April 22, 2021

Product Change Notice - New entry door automated punch machine

**New radius punch
(for optional screw
installation)**

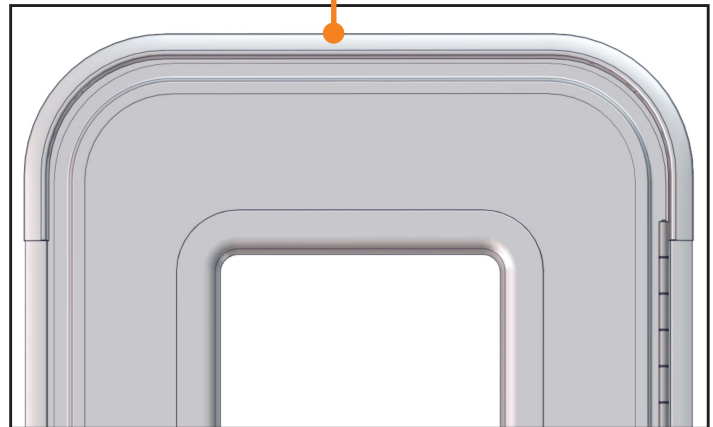
Lippert has added a new automated punch operation for entry door frames that punches the frame holes simultaneously.

The new automated punch process will help with consistency of hole placement and installation of the thresholds.

Per some customer requests, the new machine will add a punch to both sides of the radius. The radius screw locations are optional. If an OEM customer does not want to use the new screw locations, the drip cap will cover the radius and the new punches once installed.

Drip cap covers radius
